AIRCRAFT ENGINES

# SERVICE BULLETIN

## REPLACEMENT OF PIN PART NO. 929700 IN CARBURETOR FOR ROTAX® ENGINE TYPE 912/914 (SERIES) SB-912-048 SB-914-033

engine  
912/914

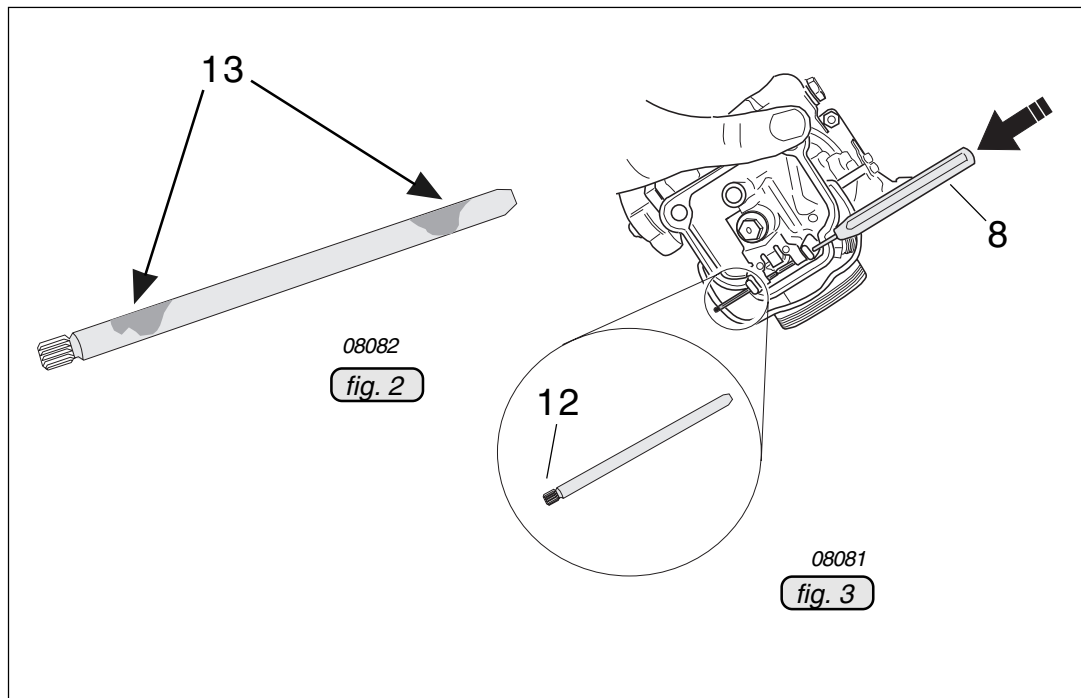
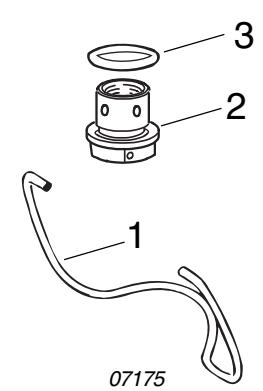
- Disconnect negative terminal of aircraft battery.
- Remove drip tray - if equipped.
- Remove carburetor.
- Open spring clip (1) or ROTAX<sup>®</sup> 914 (Series) open attachment screw (2) with o-ring (3).
- Remove float chamber (4) with gasket (5) and float (6).
- Remove pin (7) with appropriate pin punch (8) and remove float bracket (9) with float needle clip (10) and float needle valve (11)

◆ **NOTE:** The pin is serrated on one side (12). Put the pin punch on the opposite side and press out the pin. Don't damage the carb casting by pressing the serrated end through the pin support.

- Inspect the pin for flaking (13) of surface coating.
- Clean carburetor and fuel system, especially in case of flaking on the pin
- Check parts of carburetor.
- Install float bracket with float needle clip/float needle valve and the new pin part no. 929701
- Check if float suspension brackets are parallel and adjust if necessary.
- Install float chamber with gasket and float.
- Reassemble the carburetor.
- Install carburetor.
- Install drip tray - if equipped.
- Connect negative terminal of aircraft battery.
- perform basic throttle adjustment
